MBARI 4K ROV Camera Project Concept Review

November 13, 2019

Post-review notes (by Paul Roberts) have been added to notes section of slides!

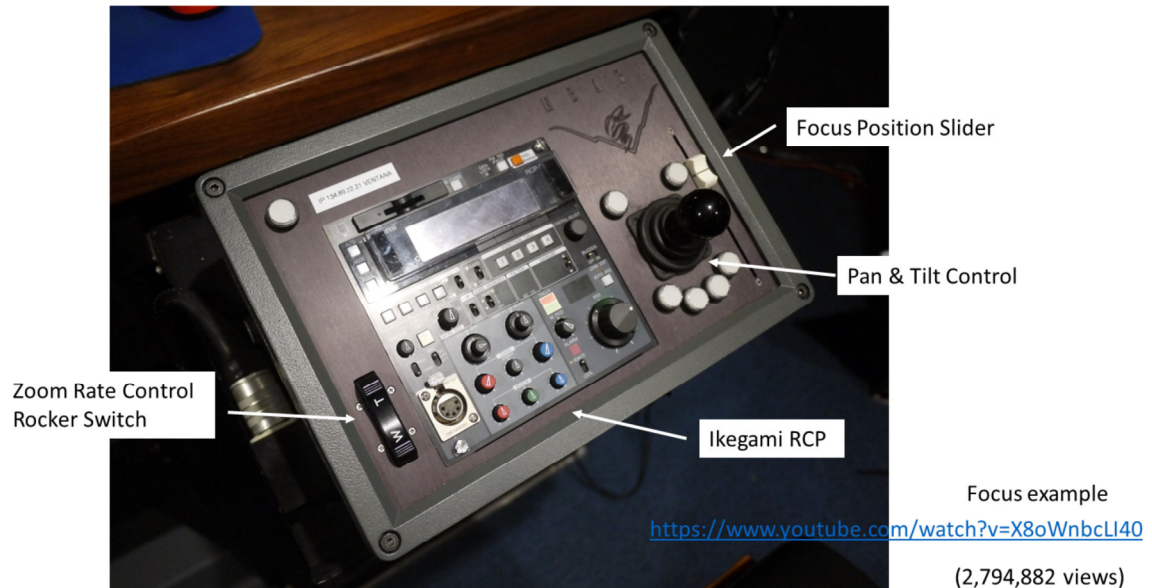
CD: The focus of the old Sony was super camera control, since then haven't experienced anything as good. Huge effort and it was great.

MC, SH, CD, KR: need to have focal setting of the lens relayed back to the system to be recorded and used later (scale est, etc)

SH: Even the current controller can be improved. Hard to focus on the photophore of fish. Didn't have fin enough control.

JB: Would be nice to have control of the fineness of focus (coarse or fine).

JB: Could have a coarse and fine slider

MC: That level of control is a requirement.

MC: Rate control for the zoom is very important.

Titanium Housing in Air Example

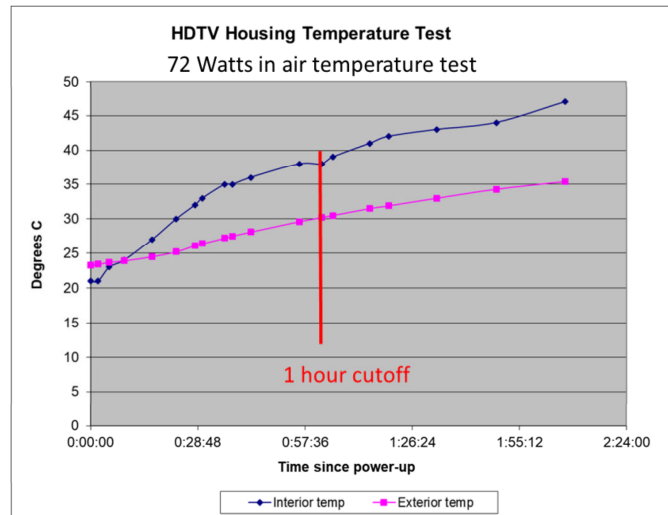
DJ: I thought it was 50 W

DJ: we may need a different connector

MC: maybe up to 80

MC: not really anyway around the power draw

(Many): temperature shutoff is a great idea!

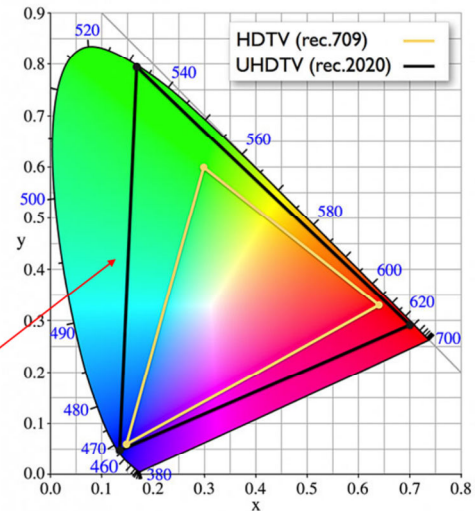
DJ: Want to move the lasers to the hemisphere

BS: Ours are off the side

MC: any shroud design needs to take into account mounting the lasers on the side

MC: Multiple shrouds for different lasers

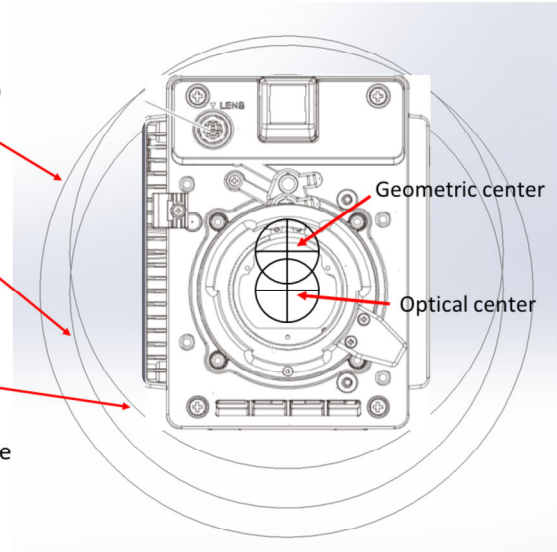
BE: Length is the bigger limit

SH: What is the length of camera+lens?

BE, BS: going to square shroud will buy us inches

MC: Shorter is better, but I think it will fit in Zeus housing

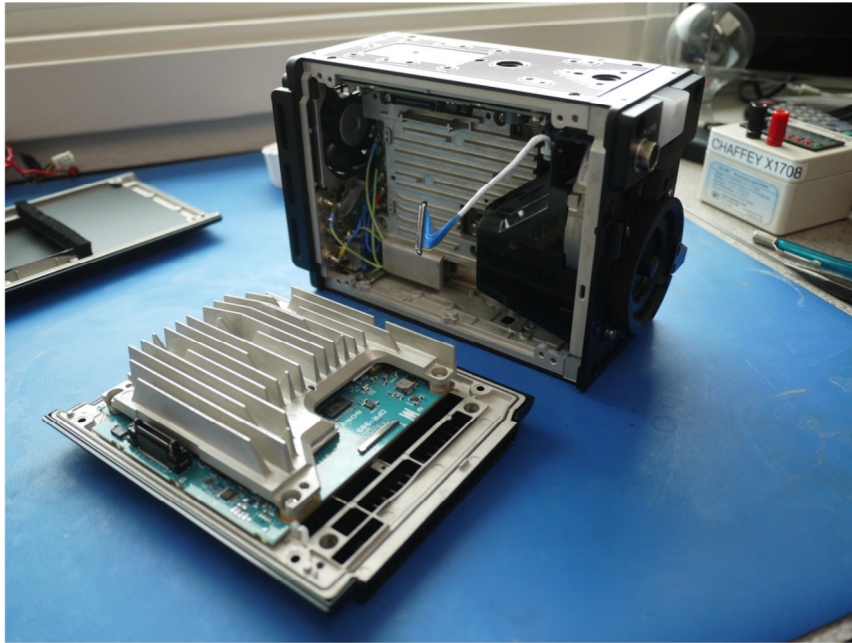
CD: can the camera fit unmodified in the larger housing?

CD: can Ricketts handle it?

CD: drop-in with a larger housing might be more appealing.

JB: Action item: what are the size and weight limits for the ricketts

Telemetry System - Top to Bottom Architecture with Off-the-Shelf Grass Valley / Telecaster Telemetry

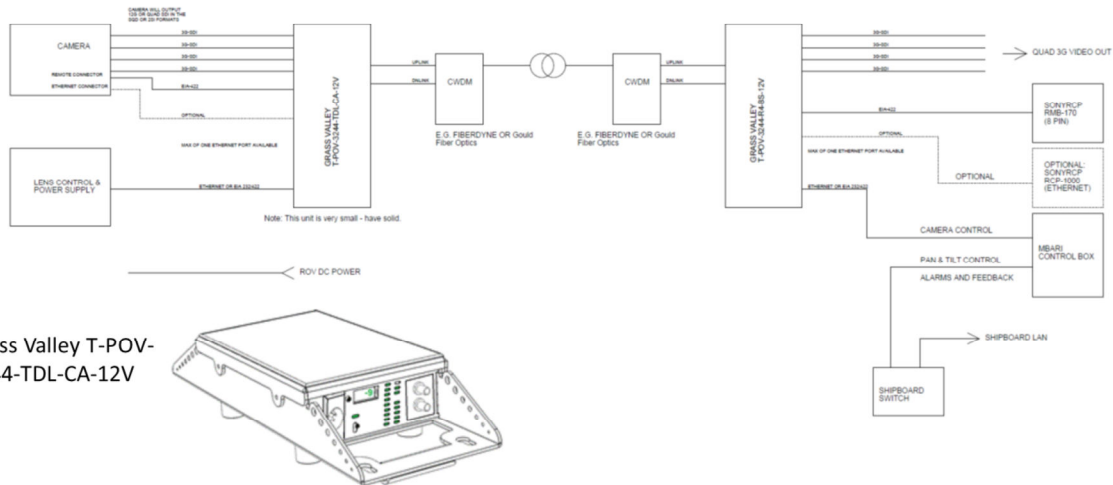
SH: zoom, focus, iris would talk to telecaster?

BS: is camera control over ethernet?

MC: simplest, least risky option for 4k

MC: it would be over serial, and that should be better for lag

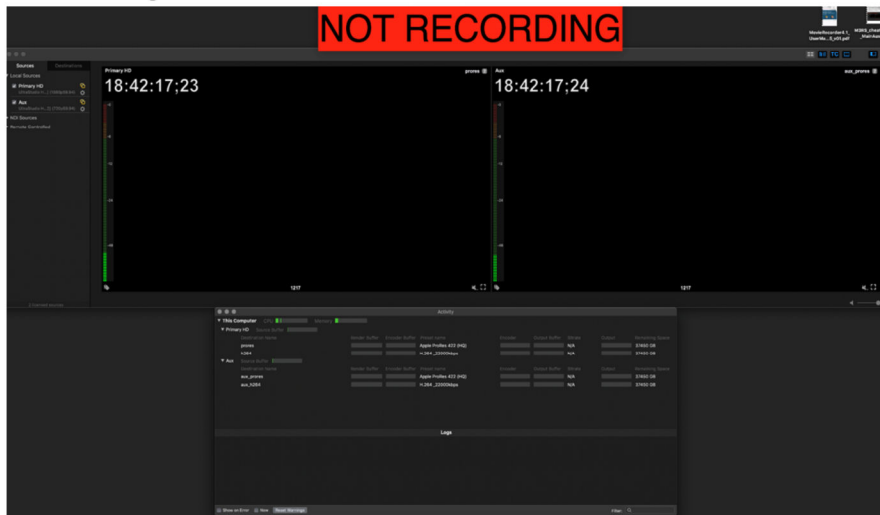
SH: can you still get the lens settings read out with analog control?

KR: so the lens has their own feedback and control?

JB: it would be nice to see how good the fujinon controls are

JB, SH: like having dual sliders

MC: proposed action is to use the analog control input and 232 to read position
